Local Planning Panel

Address: 86-90 Bay Street, Ultimo

Application: D/2026/136

Proposal

Design Advisory Panel Residential Subcommittee

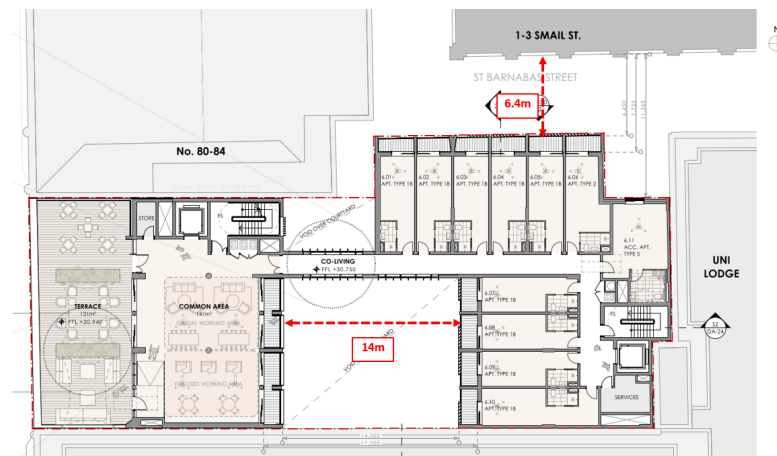
Panel reviewed application 7 April 2026. Proposal not supported, noting largely unchanged from pre-DA scheme:

- height & FSR breaches: overdevelopment & poor residential amenity
- DA should comply with SEPP building separation, privacy screens not appropriate
- floor-to-floor heights should be increased (commercial & residential)
- courtyard & roof terrace sizes should be increased for better amenity
- room widths should be increased to DCP minimum
- laundry should in better location
